# ADDENDUM NO. 04

Date of Issuance: March 26, 2025

Project: **2022 BOND – New Williams Elementary School Replacement**  
Pasadena Independent School District

11 INT - LIBRARY KIVA A141 - W  
1/4" = 1'-0"

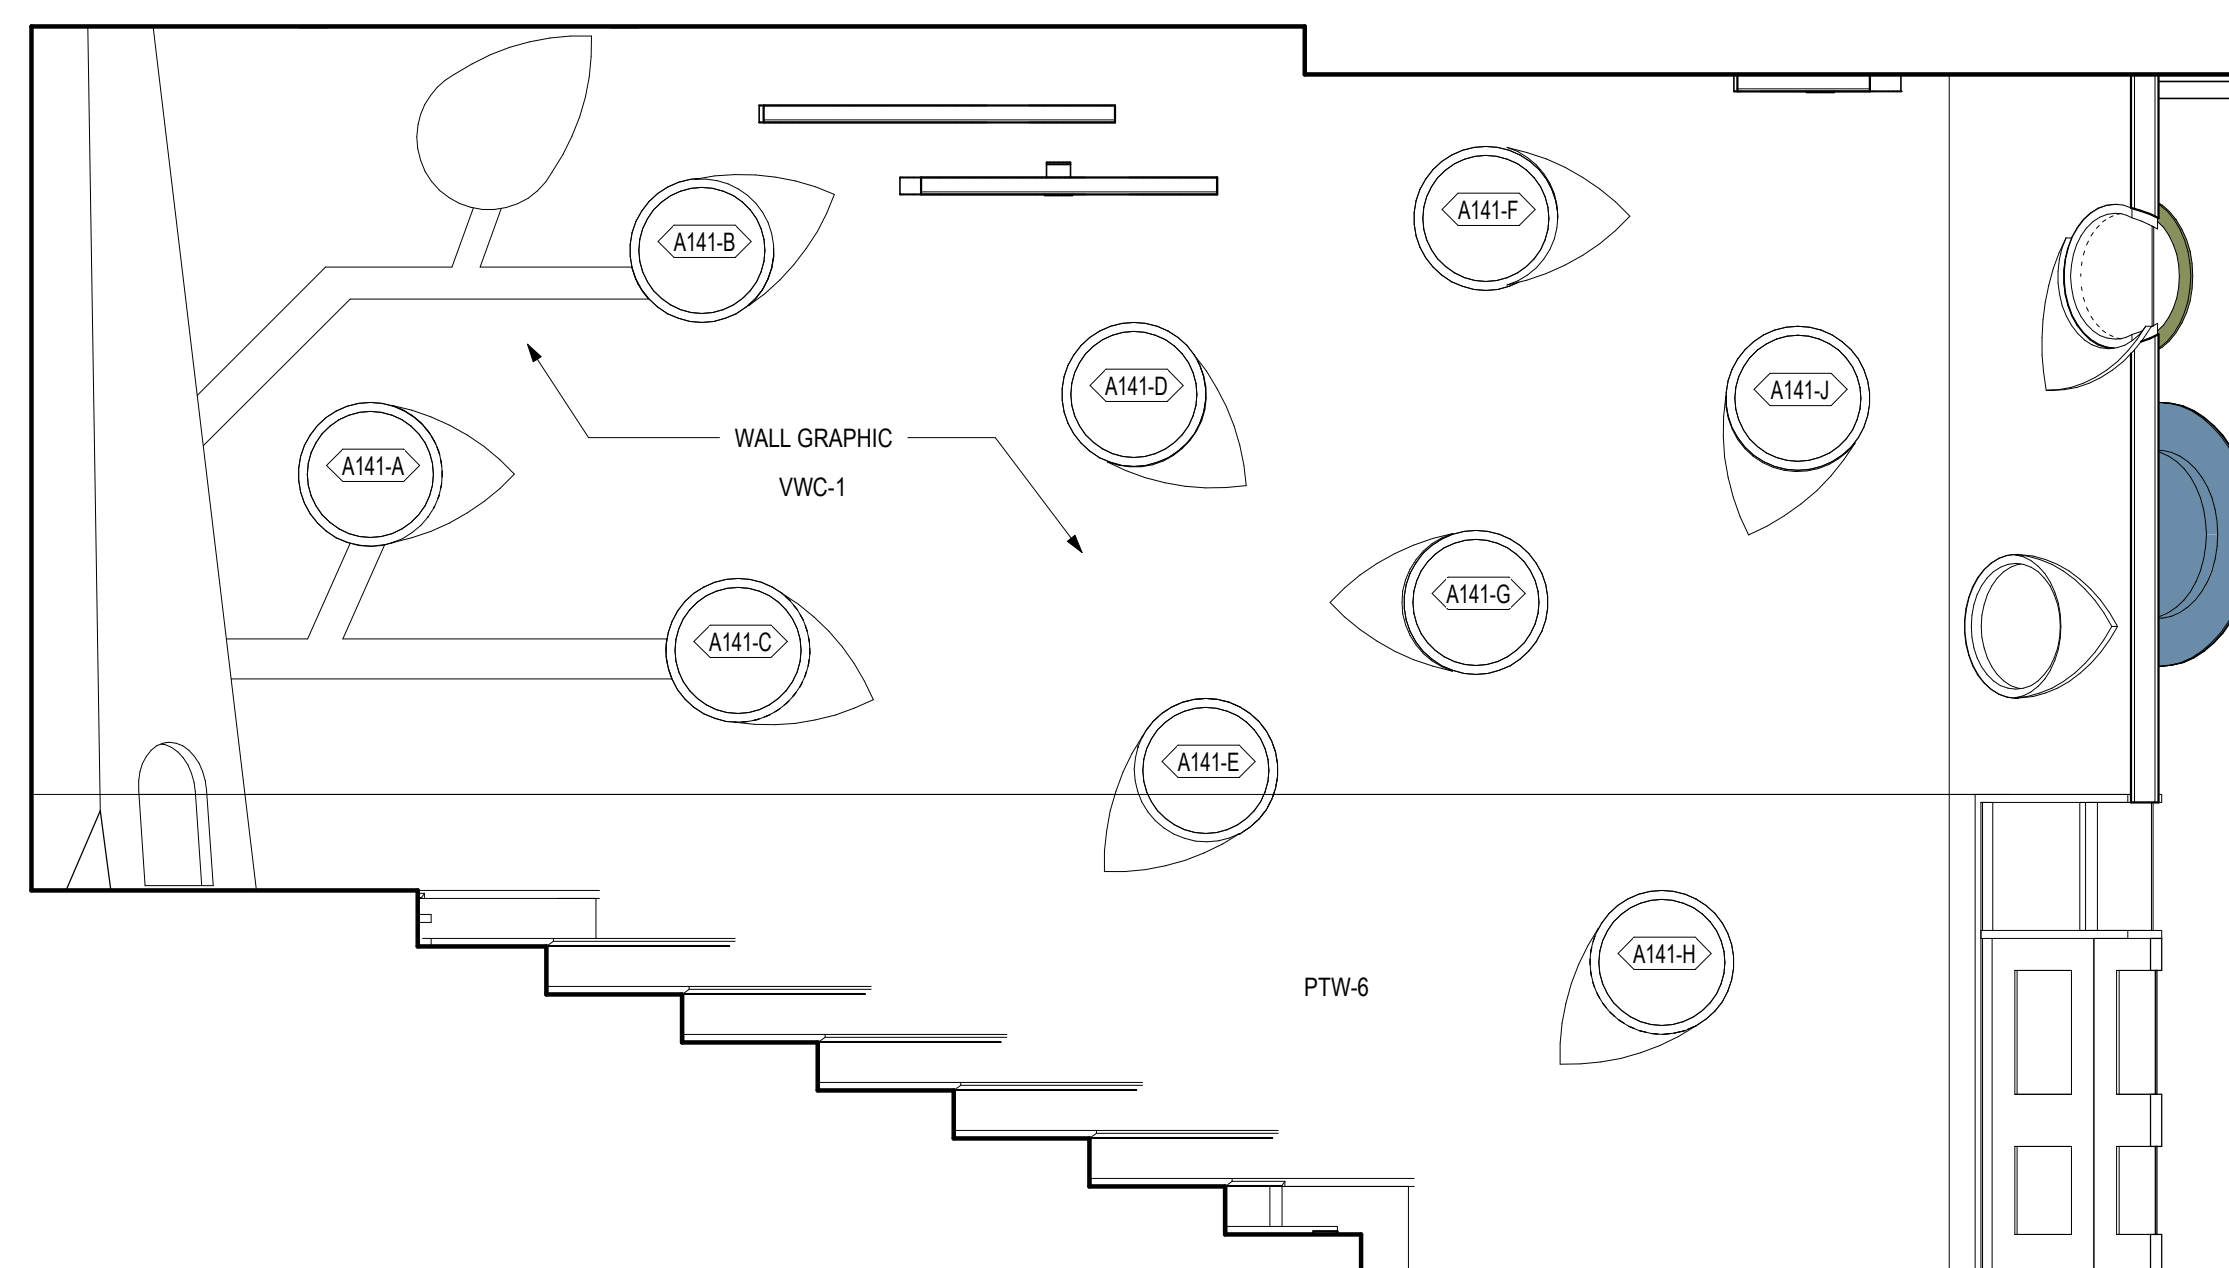
1. Sheet A7.07 – Interior Elevations
  - a. Revise Detail 08
  - b. Revise Detail 09
  - c. Revise Detail 10
  - d. Revise Detail 11
2. A7.08 – Interior Elevations
  - a. Revise Detail 15
3. A7.09 – Interior Elevations
  - a. Revise Detail 1
  - b. Revise Detail 2

15 INT - CORR. A127 - W  
 1/8" = 1'-0"

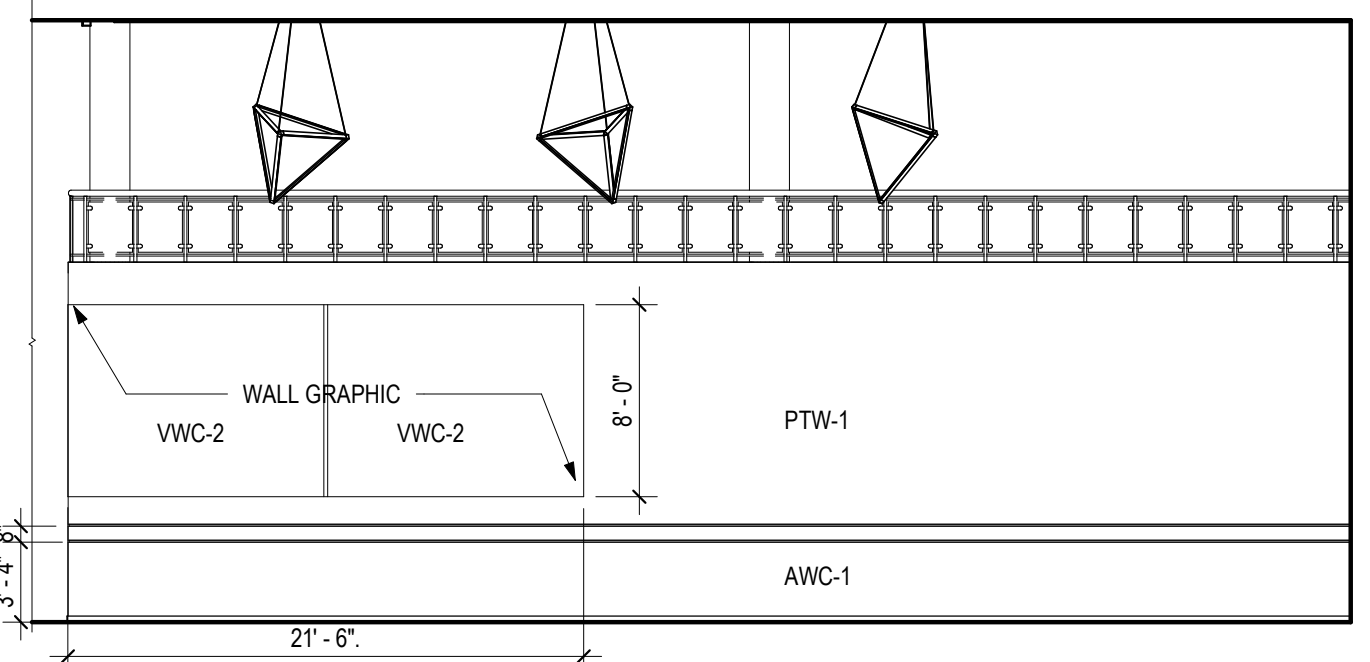
<b>52</b>	RE: Question regarding upholstery fabric selection. For the cushions to be bid, an upholstery fabric needs to be selected (color would be nice, but upholstery fabric type is necessary).	Use Silvertex Vinyl Whisper Vinyl through Burch as reference.
<b>53</b>	What graphics are expected to be priced in the base bid? The material & labor allowances show a supergraphics & graphics allowance but don't specify which ones. Please advise	Ref. place holder on 2/A7.09 and 15/A7.08 and Library Interior A707. Add graphic design labor for wall graphic installation coordination.

**3** INT - RECEPTION A102 - NE  
 1/4" = 1'-0"

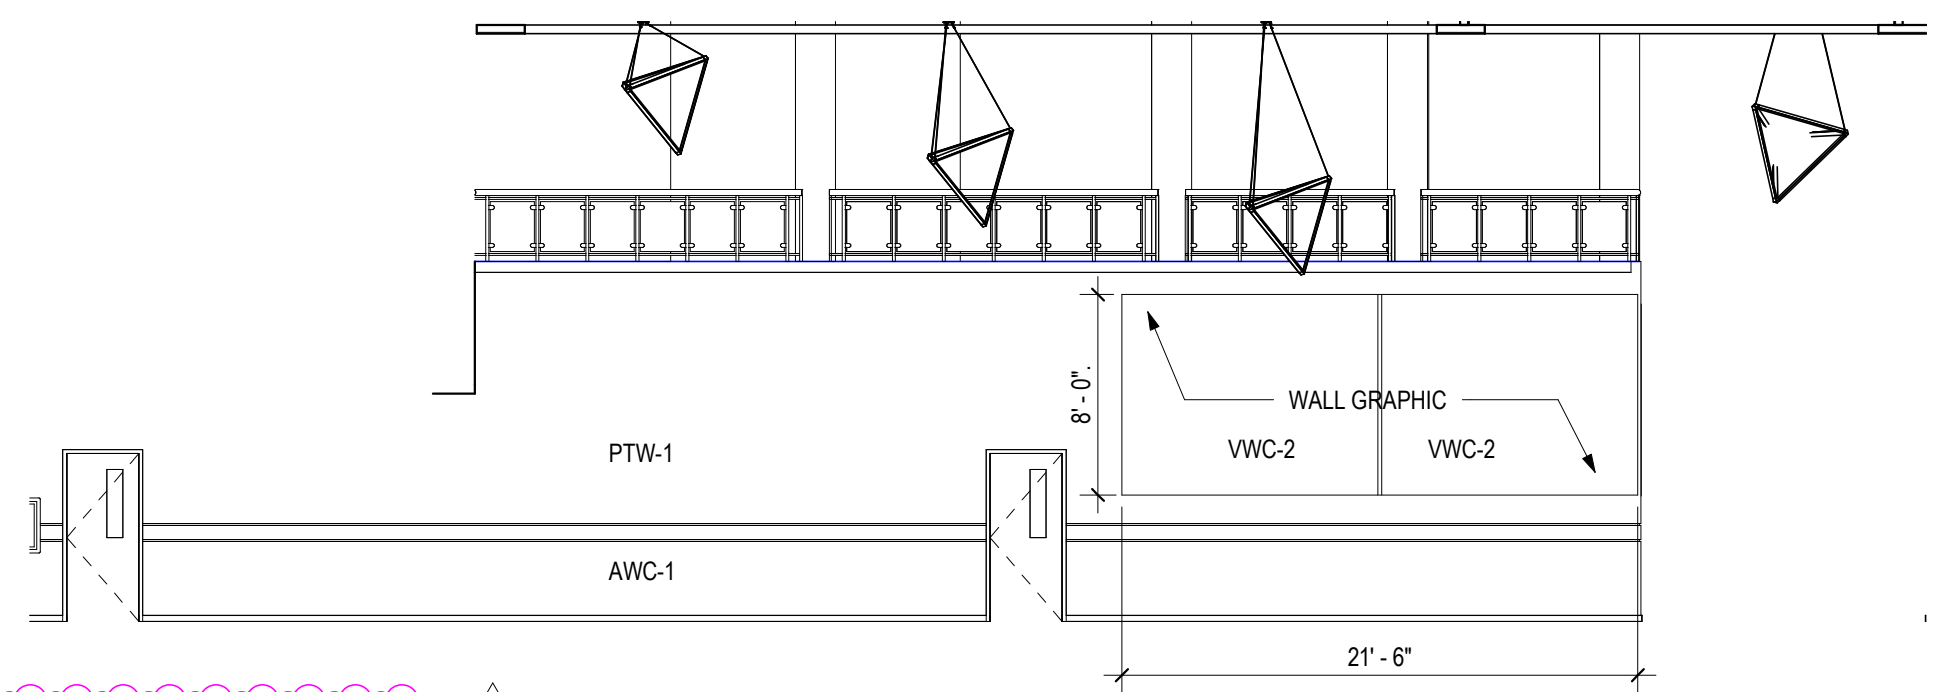
80	<p>3/A7.09 According to referenced detail – the contractor will need to enter an existing school to remove an existing stage floor. Will this need to be done after school hours?</p>	<p>Coordination required with PISD.</p>
81	<p>If removal of the existing stage floor is required after school hours, will Contractor need to pay school personnel to be present and have the school open? If yes, what is the hourly rate charge?</p>	<p>Coordination required with PISD.</p>
